PERCOLATION TESTING

HOWARD COUNTY HEALTH DEPARTMENT
BUREAU OF ENVIRONMENTAL HEALTH
3525-H ELLICOTT MILLS DRIVE/ELLICOTT CITY, MARYLAND 21043
TELEPHONE: 313-2640

RE-PERC
FOR SEWAGE ~~ADJ.~~
EASEMENT ADJ.
FOR NEW DECK &
OTHER IMPACTS

RE: PERCOLATION TEST RESULTS
A 58527
King's Grant, Lot 8
3212 Parliament Place

LOT 8
3.3867 AC

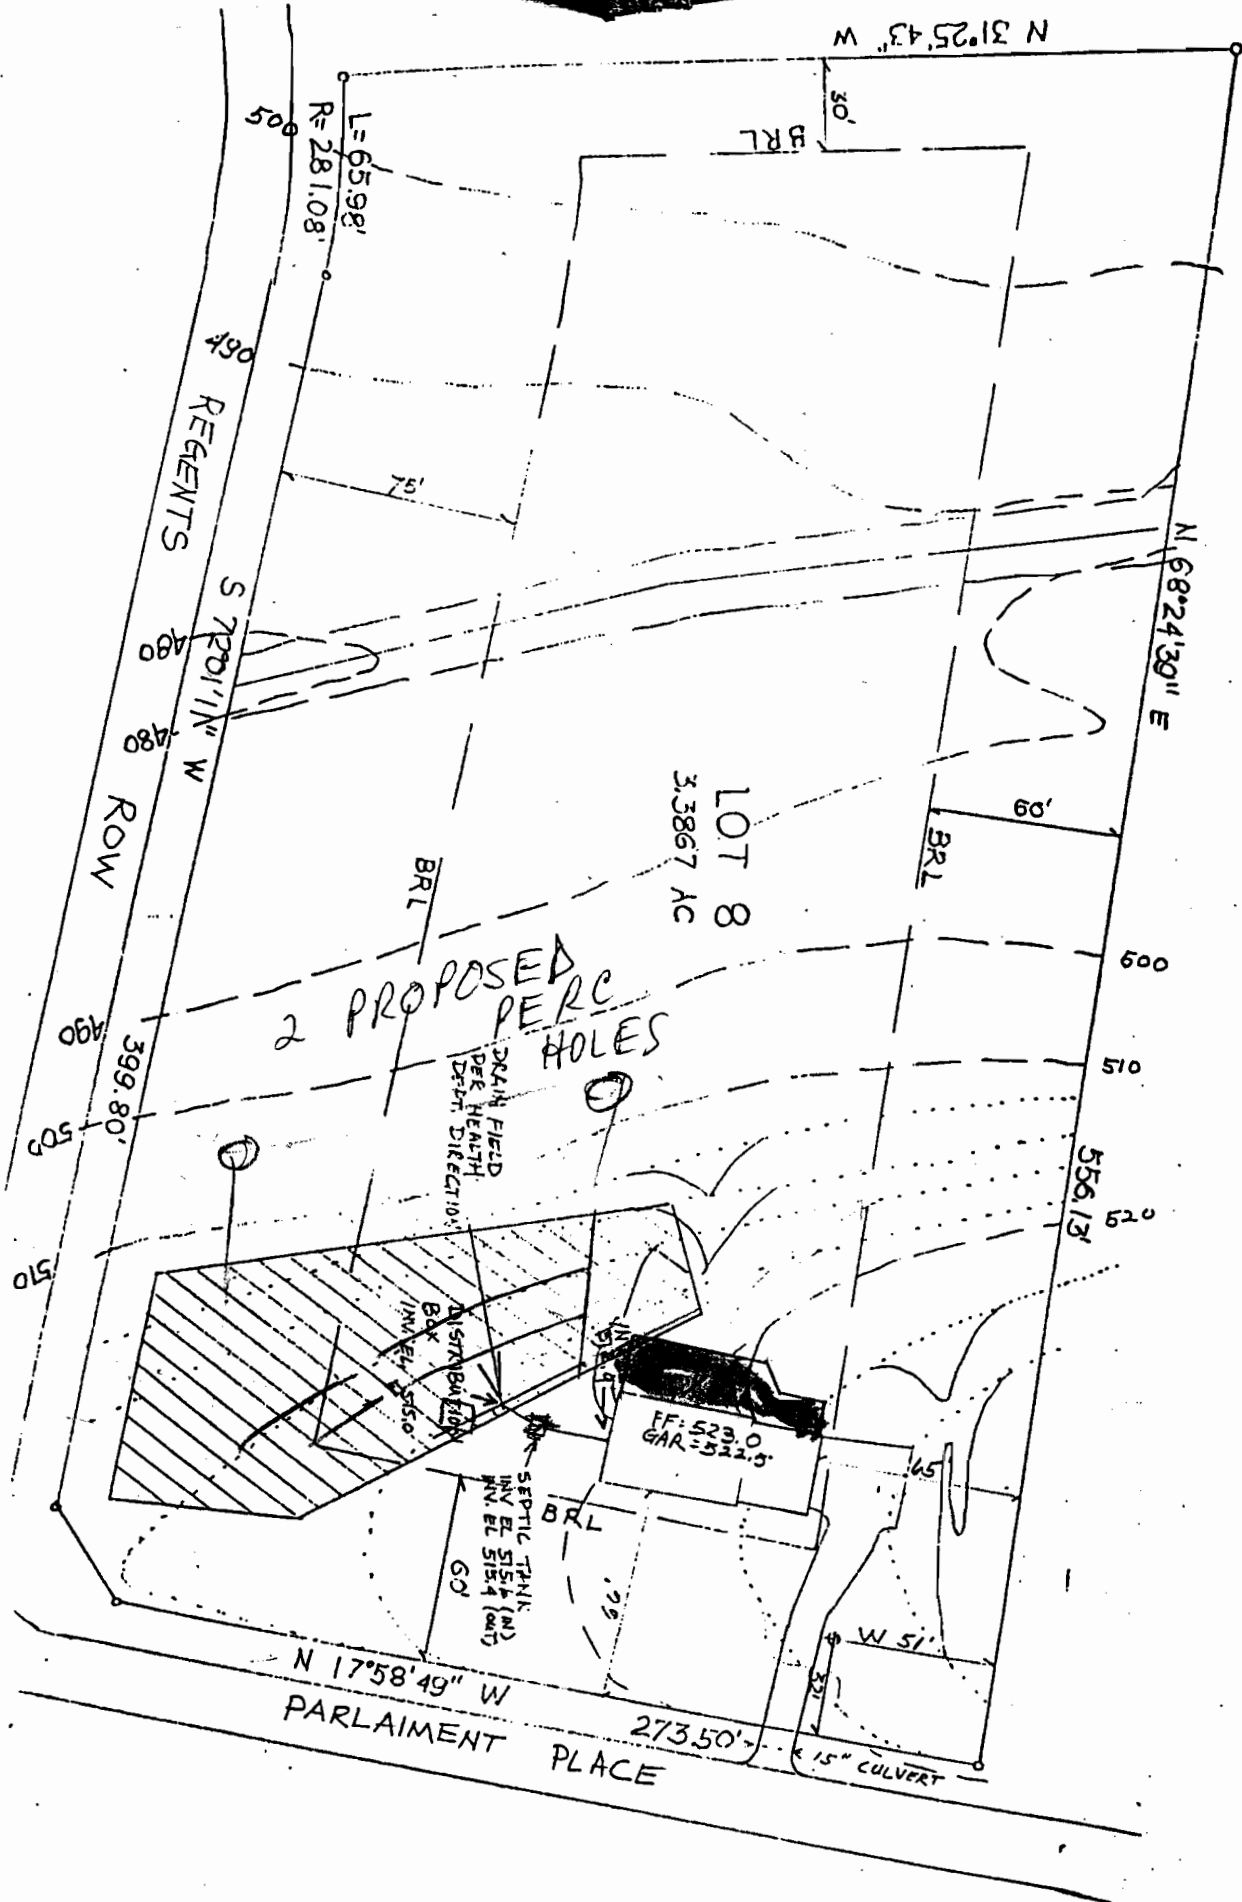
This testing was requested during review of a building permit application for a proposed deck which would violate suitable setback standards by adjoining, if not encroaching into the existing sewage easement. The testing was conducted to establish suitable sewage easement area to replace that area lost by the encumbrance of the proposed deck and other causes, including grading.

Further review is contingent upon submission of a reasonably competent percolation certification plan showing the actual location and elevation of the excavated test hole and proposed sewage easement revision. The plat should also include the locations of the existing house, well, septic system and sewage easement on the property as well as the locations of any other relevant features such as streams or swales. A note must be included certifying that all existing wells and septic systems within 100 feet of property boundaries have been shown.

This should be submitted within 60 days to allow field verification if necessary. If you have any questions regarding this matter, please feel free to contact me at the above address or by calling (410) 313-2640.
